**RESPONSES TO FERC'S DEFICIENCY
LETTERSTS IN LETTER DATED OCTOBER 28,
2020 – FILED MARCH 31, 2021**

Scott's Mill Hydropower Project

FERC Project No. 14867

RE: *SCOTT'S MILL HYDROELECTRIC PROJECT*
FERC PROJECT NO. 14867-001
RESPONSES TO COMMISSION LETTER OF OCTOBER 28, 2020

General Project Location Map

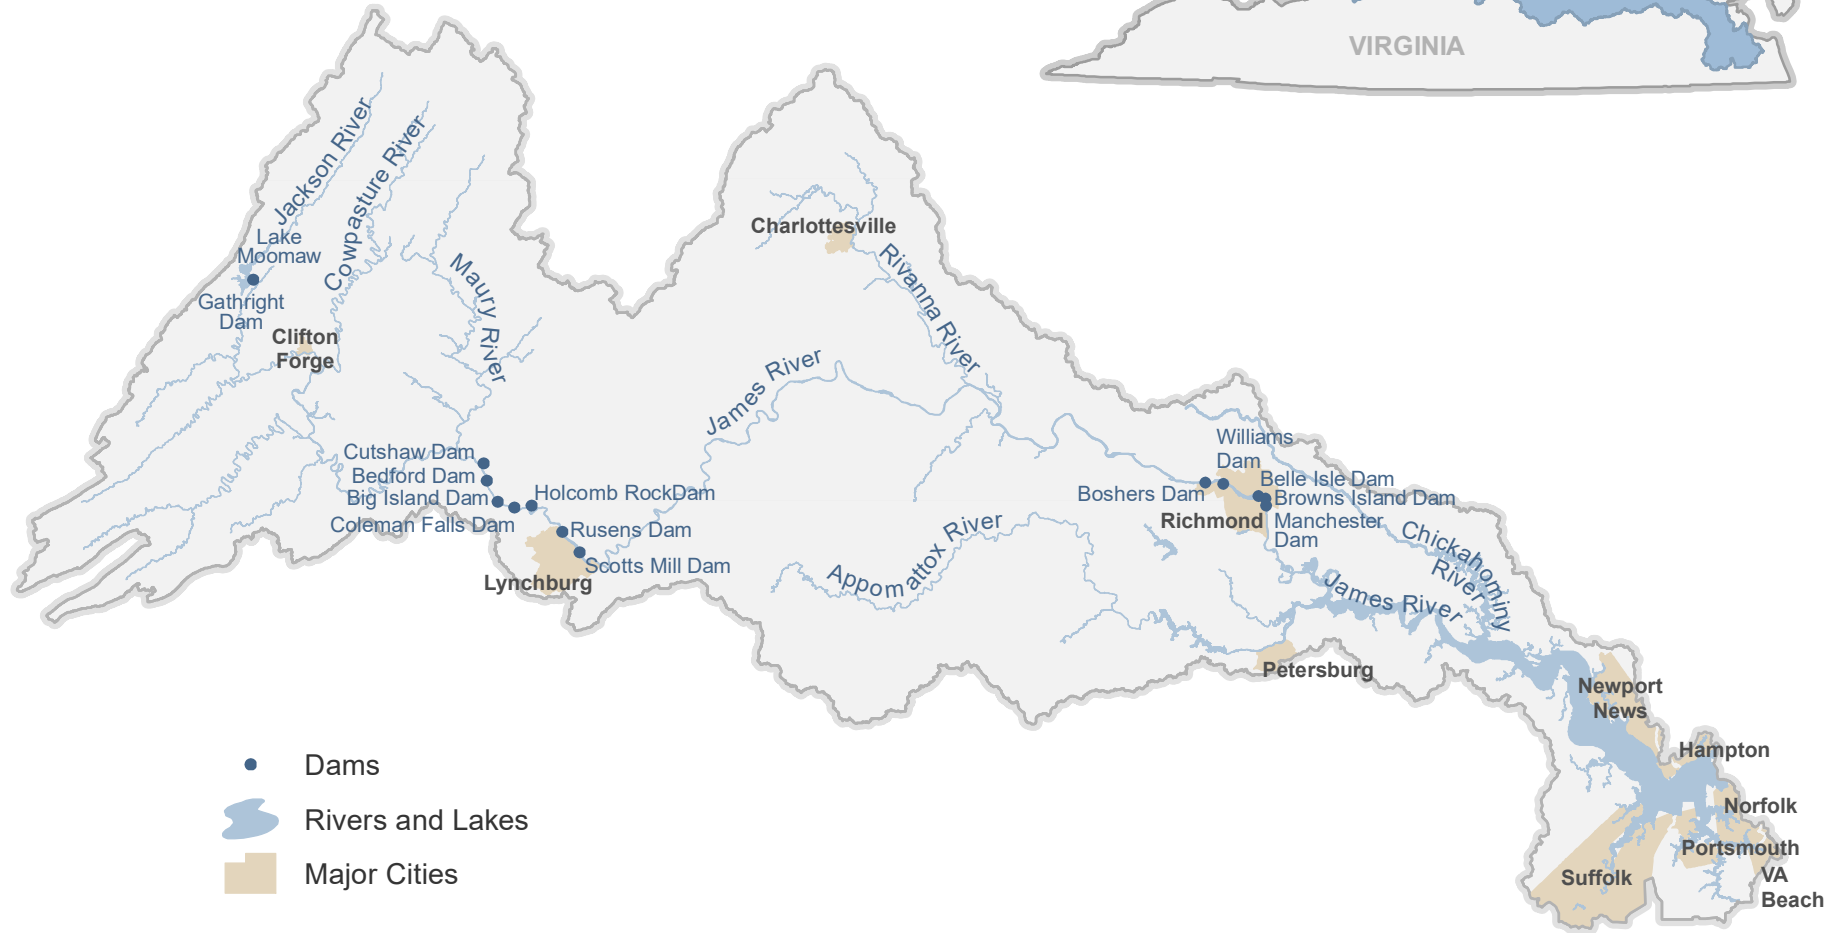
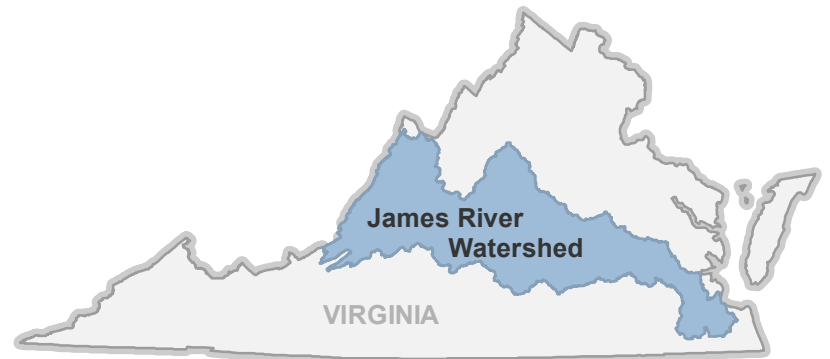
9. The project location map (figure A-1) in Exhibit A is difficult to read and interpret. Please modify the map by providing an inset (watershed) map that is separate from and does not blend into the main map; also include a scale bar on the main map.

Figure A-1 has been modified to add a bar scale and clearly separate the inset from the location map.
